2022-XE-NRC-017

Submission of X Energy, LLC (X-energy) TRISO-X Pebble Fuel Qualification Methodology

**X Energy, LLC
Xe-100 Topical Report,
“TRISO-X Pebble Fuel Qualification Methodology, Revision 3”
(Proprietary)**

Figure 25: Assumed Performance Envelope for Qualification of AGR Fuel

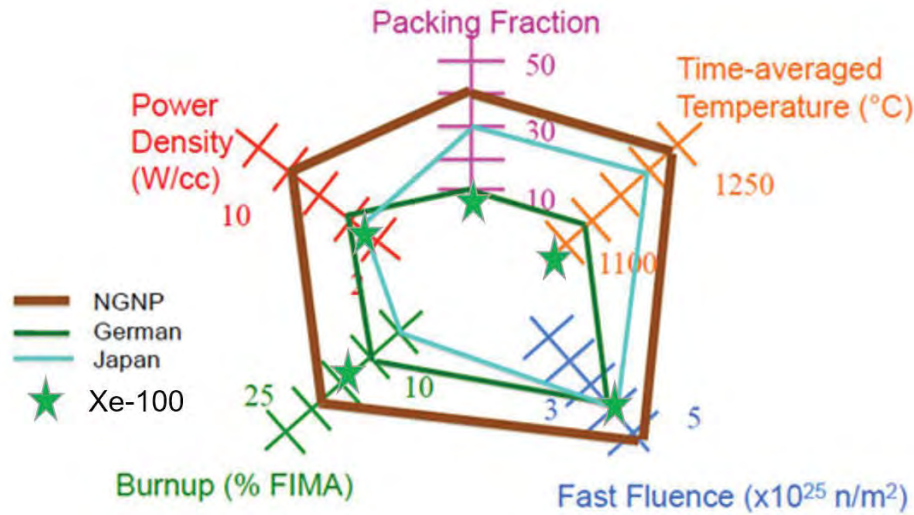
B) Figure 25 identifies preliminary design performance envelope and associated parameters of interest. Additional parameters of interest may appear in future submittals. Power per particle may appear in future submittals but is derived from power density from Figure 25. X-energy also plans to submit maximum accident temperature versus time at temperature and associated ramp rates as figures of merit for accident analysis. Additional figures of merit that may impact fuel qualification identified in future topical reports or submittals will be presented to the staff for evaluation.

The X-Energy preliminary design performance envelope is identified within Figure 25: Assumed Performance Envelope for Qualification of Advanced Gas-cooled Reactor (AGR) Fuel. The preliminary design performance envelope for the Xe-100 core (green star) is comparable to the German envelope shown in the figure and well within the performance envelope for the NGNP that serves as the basis for the AGR Fuel Program.

Figure 38: Simplified Flowchart of the PIE Protocol

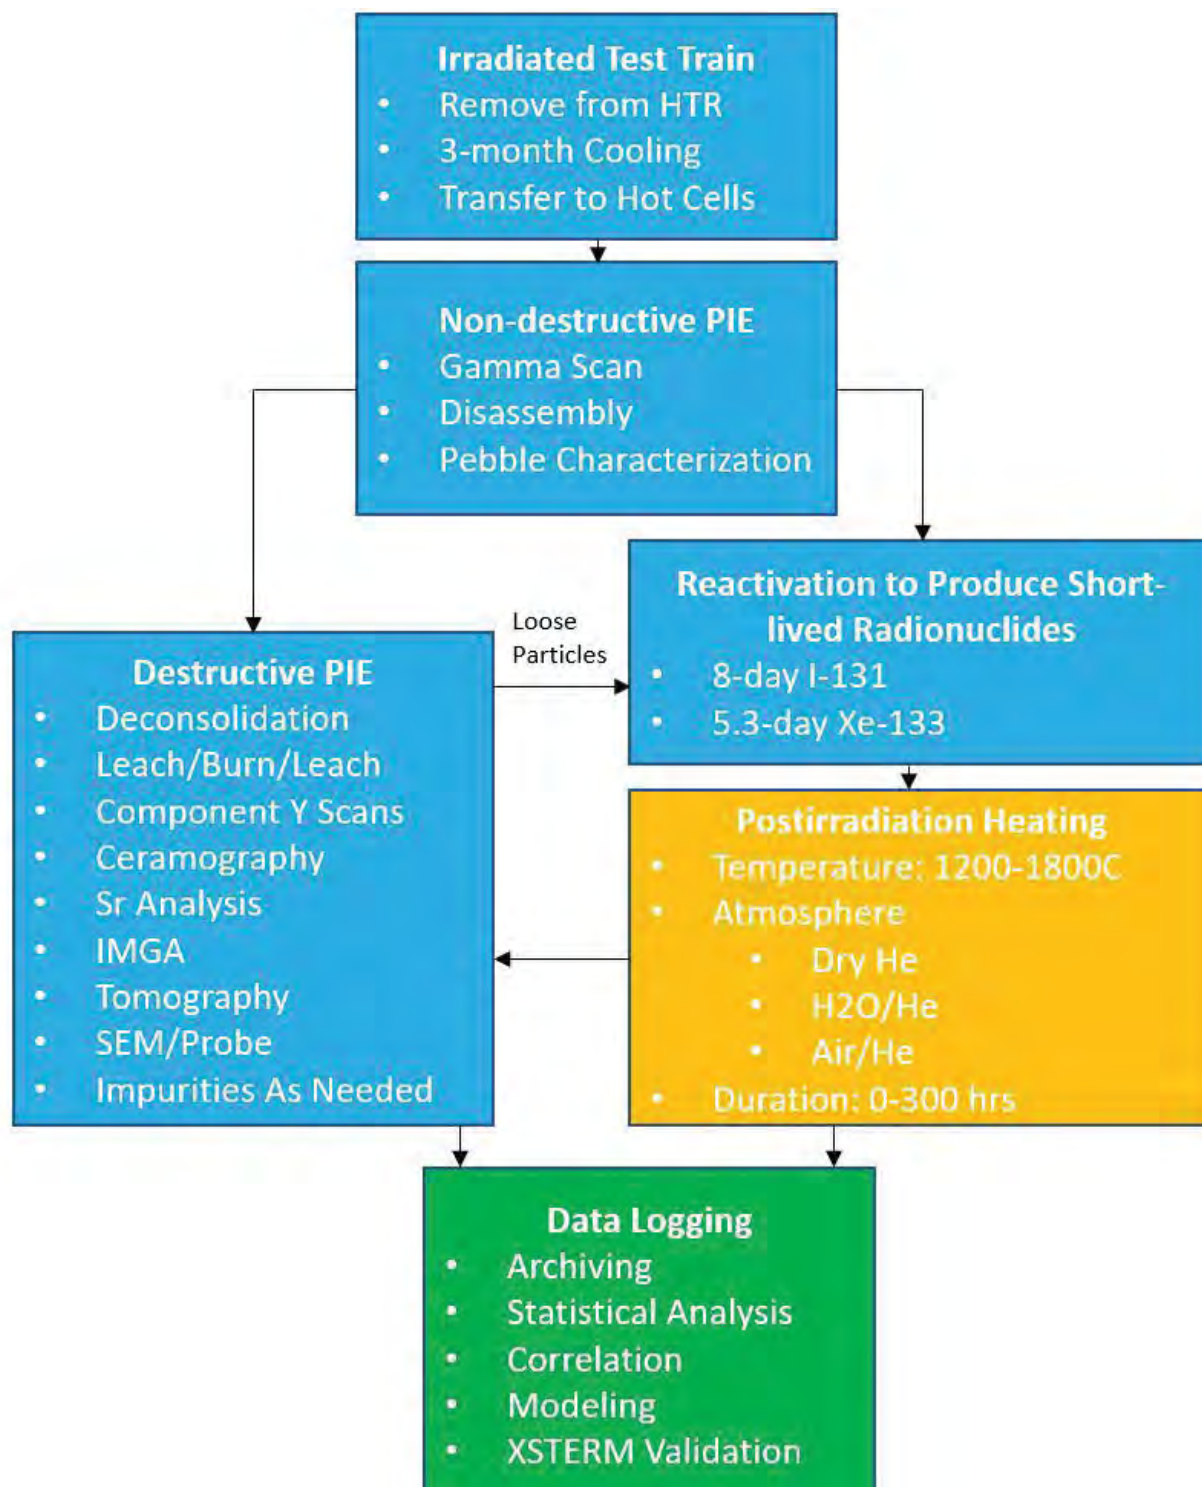
5. Please discuss the role of Figure 38 with respect to the tests that have been performed and those to be performed.

Figure 38 of the Fuels Qualification Methodology Report shows a simplified flowchart of the Xe-100 TRISO Post Irradiation Examination (PIE) Protocol.

A) X-energy intends to perform this process for [[]]^P material exactly as shown in the Figure 38 flowchart.
